# INTERIOR

## SRS AIRBAGS <EVOLUTION-V GSR>

#### <EVOLUTION-IV GSR>

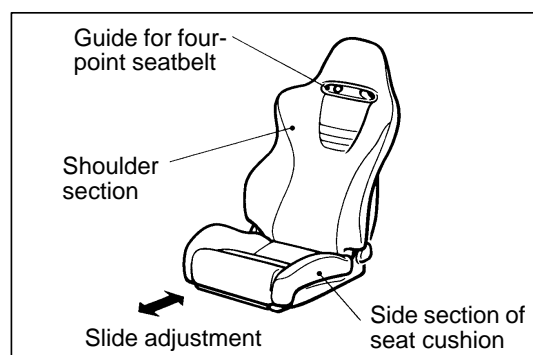
The GSR's front seats are made by Recaro. They are basically the same as the Recaro front seats of the EVOLUTION-III.

The shape of the Recaro seats has been revised.
